Docket Item # 1 & # 2
BAR CASE # 2016-0363 &
2016-0364

BAR Meeting
December 7, 2016

ISSUE: Partial Demolition/Capsulation and Addition/Alterations

LOCATION: 412 Wolfe Street

EAST ELEVATION - EXISTING / DEMOLITION

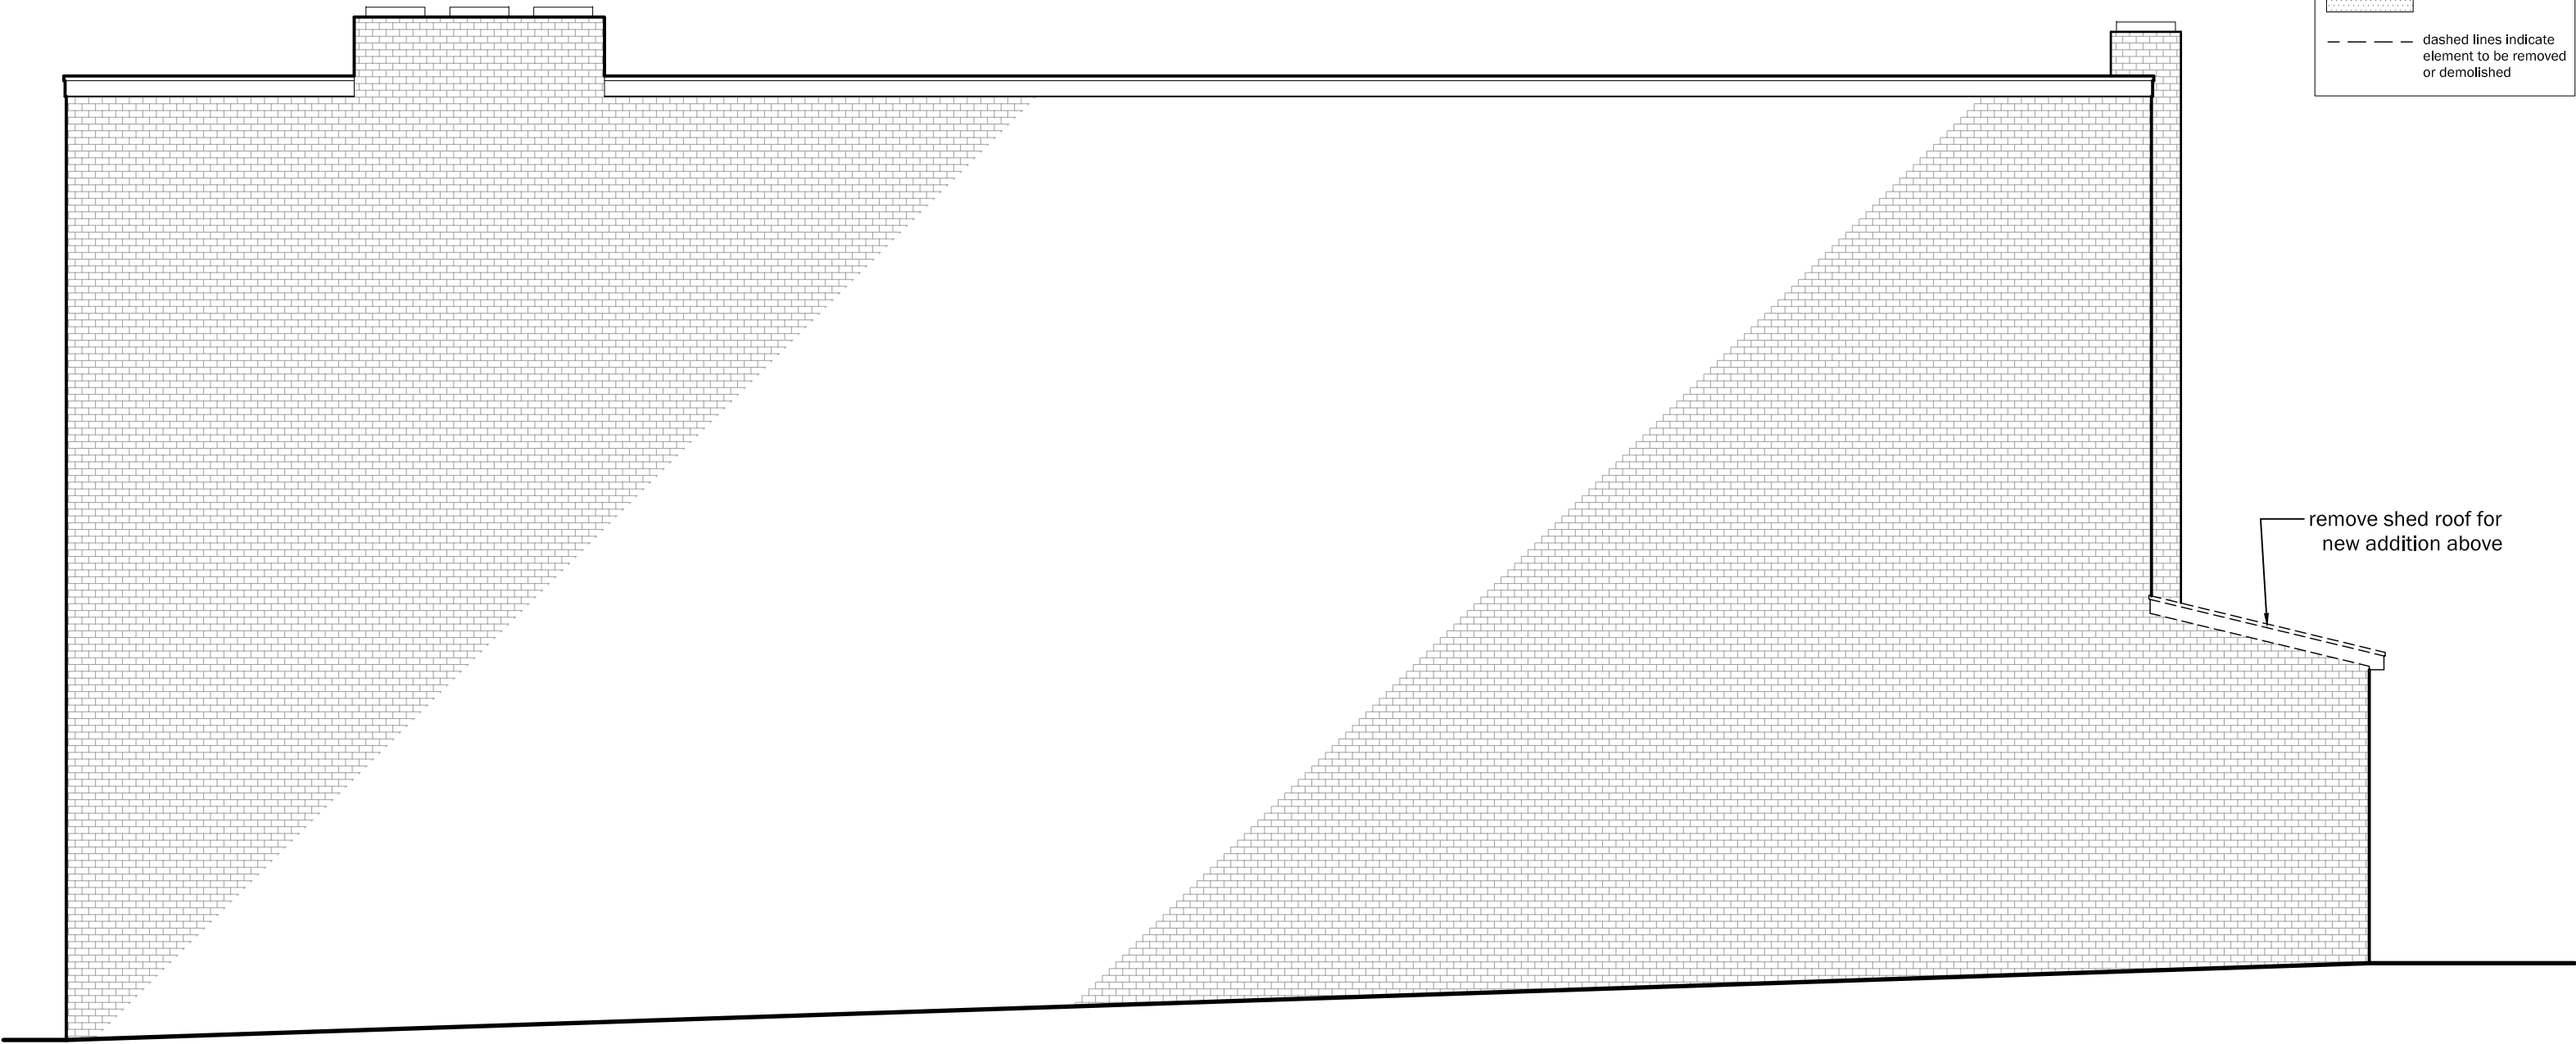
The Board spent a significant amount of time considering the porch reconstruction and column design, looking at it from both the street (north) elevation and the side (east elevation). The Board was most troubled by the use of different sized columns, particularly on the first floor, due to the two different brick plinth heights. The original plans did not fully illustrate the awkwardness of the current design with two existing brick piers at the front gate in front of the wall, resulting in both inner and outer piers beside each other. The current proposal will demolish the two brick piers (the "outer" piers) and reinstall the gate at the new brick pier of the foremost column. Staff worked with the applicant to study various ways to transition both the gate and successfully reconstruct the two-story porch with new columns. Staff finds that the current scheme mediates the front column's function as both a column in the overall porch design as well as the pier used for the gate. The applicant achieved this by lowering the brick garden wall height to the column plinth height. The garden wall will be altered with the addition of an open metal fence. The existing metal gate will be reused. Staff supports this approach which resolves both the column design and the front approach.

1. Front Entry at Driveway/Existing 2-story Porch:
 - (2) existing OUTER pillars to be demolished to accommodate existing driveway circulation and clearances.

- existing INNER pillar at first post to be lowered to accommodate a new tall decorative column to match all other tall columns on East Elevation.
 - existing front garden wall to be lowered to match existing lowered INNER pillar

- existing metal gate to be relocated from demolished outer pillars to space between first column and existing house.
2. Modified Scope of Work at Back-half of Structure:

- Delete proposed 2-story box bay and First Floor Addition.
 - Existing secondary landing to remain with a new shed roof over existing door.
 - (2) existing bowed bay windows to be replaced with box bays with casement window units.

PROPOSED FRONT AND REAR ELEVATIONS

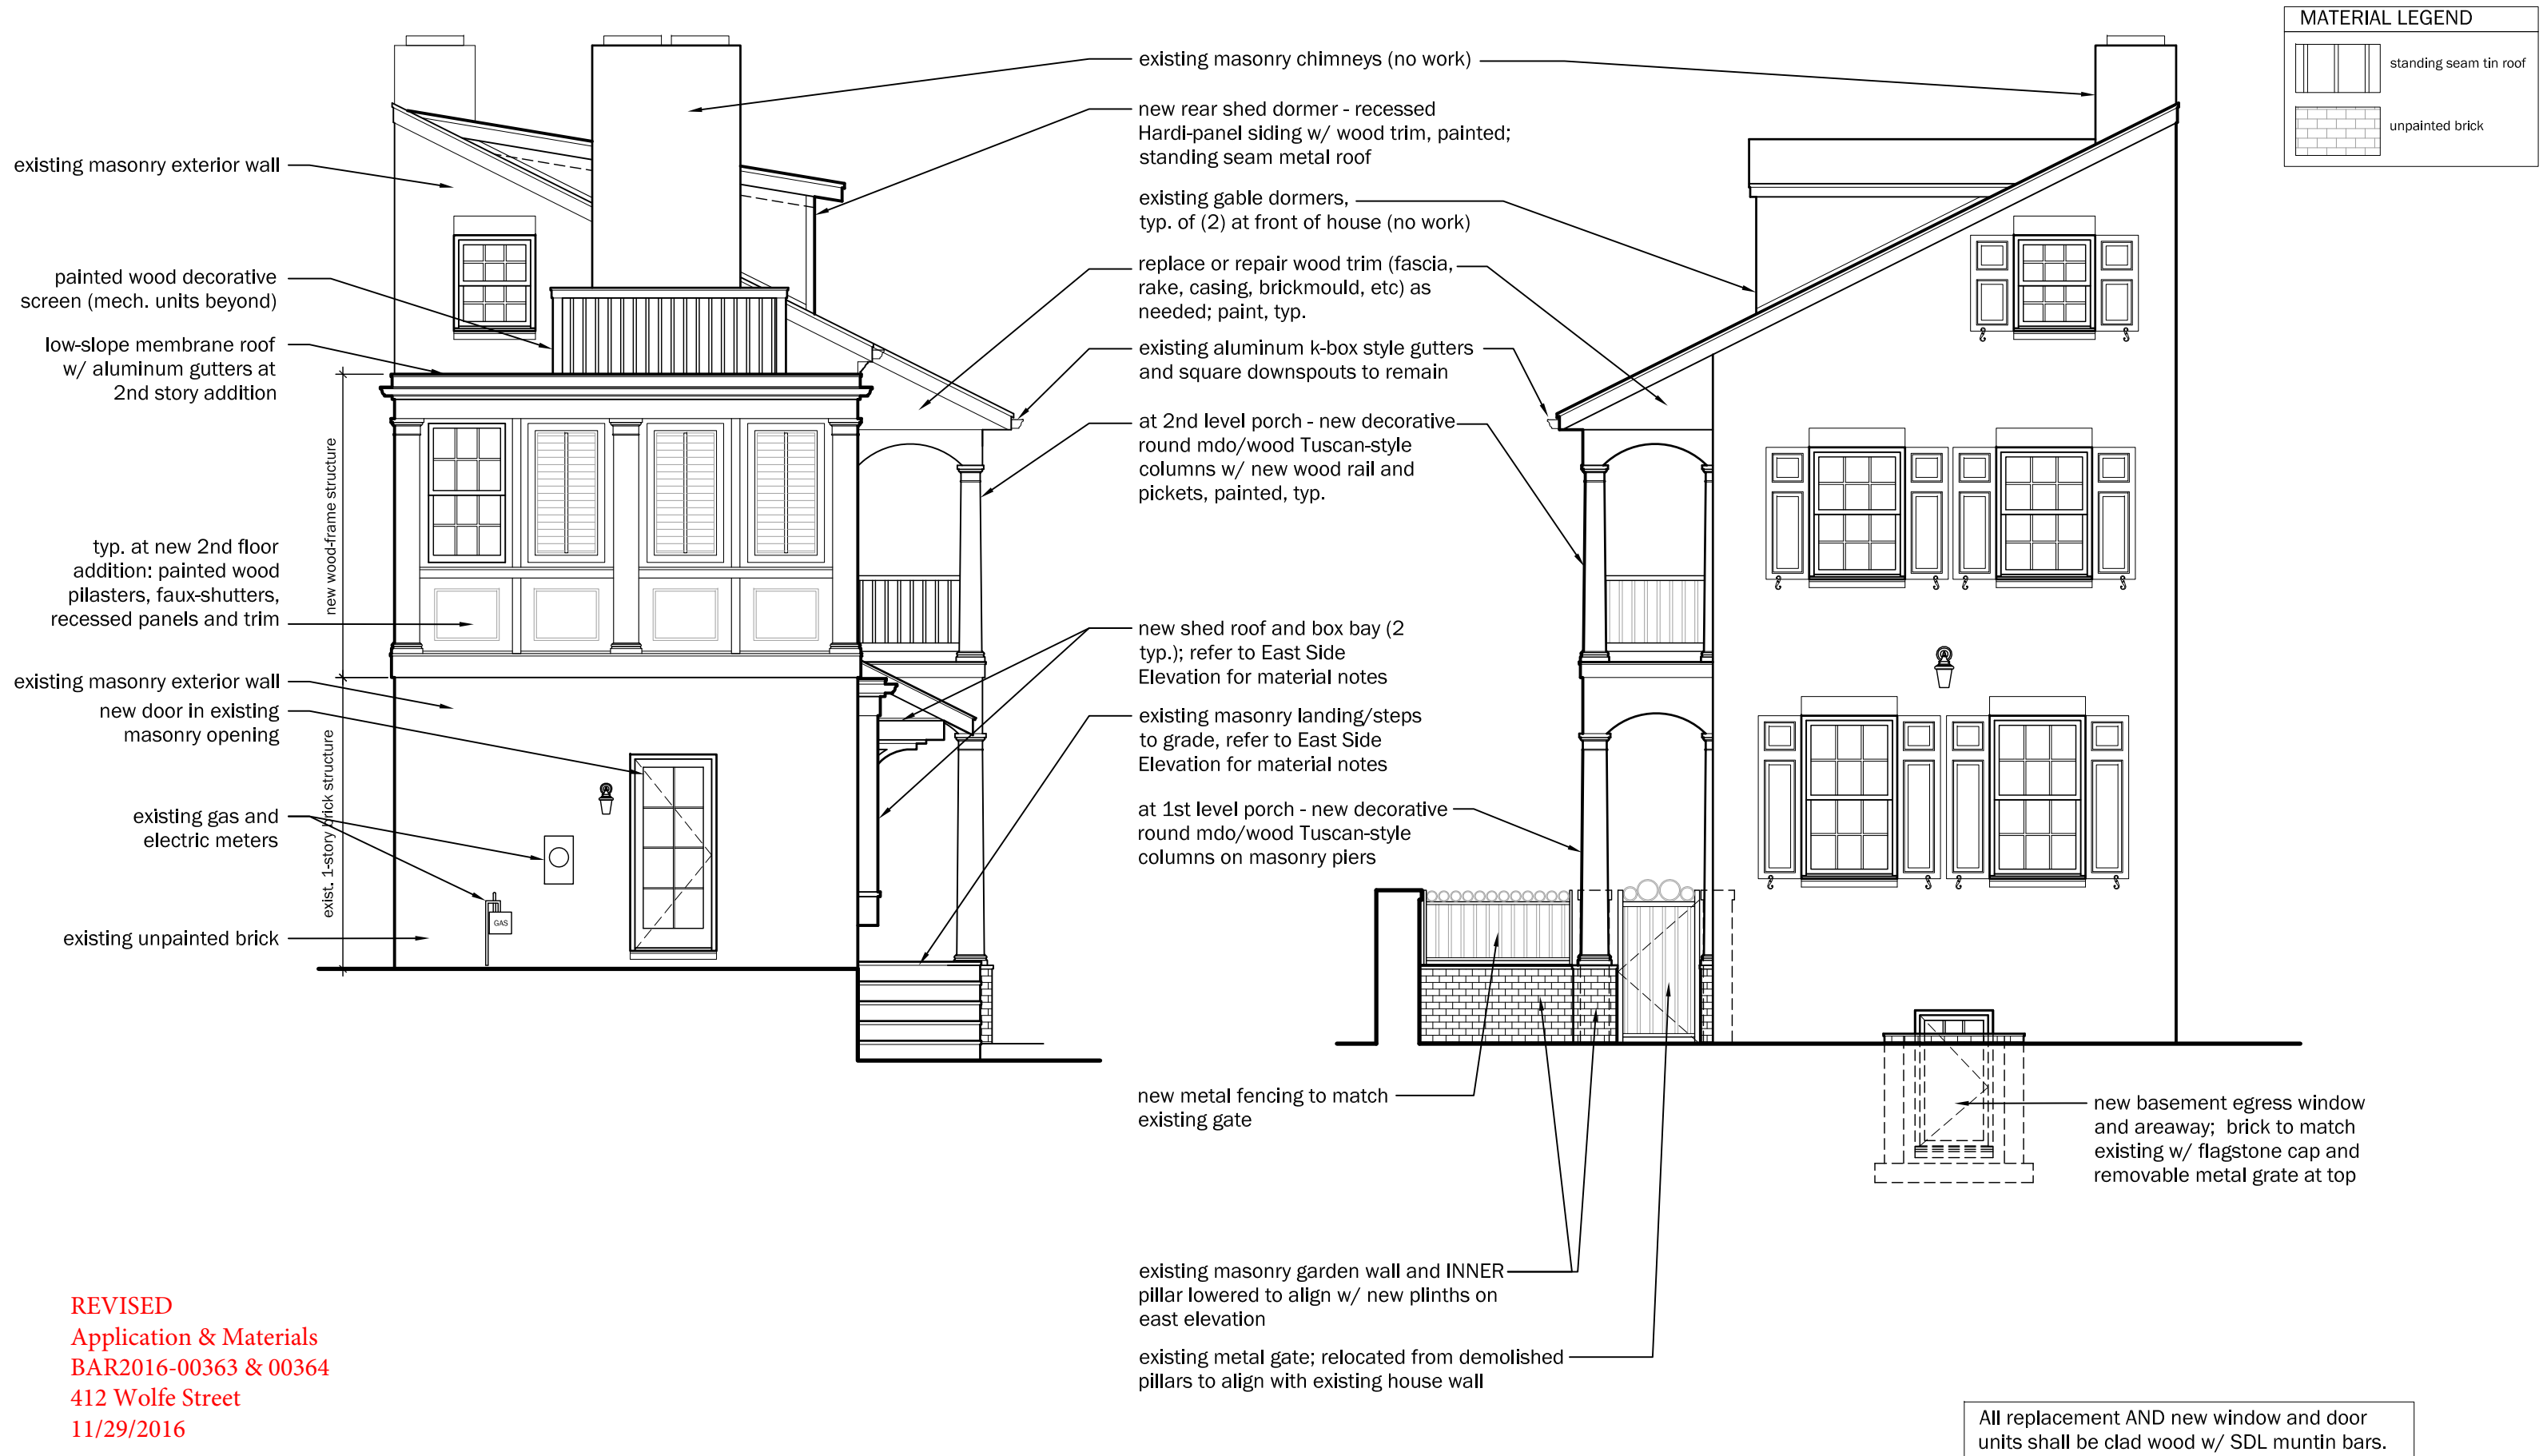
relatively limited due to its location set back from Wolfe Street. Although the alley to the rear is private, the second story addition will be visible from South Pitt Street. The construction of a second story addition over a one story addition is a common approach for expanding a house without expanding the footprint. This particular addition will read as an enclosed upper story rear porch, a common design solution. *Staff had previously recommended that this second story addition be refined and the Board agreed and offered additional design solutions. The project architect has refined this element by including panels and closed shutters with a more appropriately sized window on the south elevation. Staff supports the revised rear addition as submitted.*

The replacement windows must meet the performance standards listed in the BAR's Window Policy. *Acknowledging that there are two distinct building blocks—the front section with the two-story porch and the rear section with the bow windows (to become box windows), the project architect has used window light configuration and size to help define and further distinguish the two major elements. For the rear block, an existing small window above the door became the window size reference standard for both the existing windows and the new windows in the shed dormer and the box bays.* The construction of a painted wood railing on the new rear addition will adequately screen the proposed rooftop mechanical equipment in that location.

- (2) existing small windows at First and Second Floor modified to be replaced with 2W/2H casement units.
3. New Second Floor Addition and New Third Floor Dormer:

- Window units modified to be 2W/2H casement units, sized to match replacement units at lower floors.
 - Siding to be recessed Hardi-panel w/ wood trim, painted.
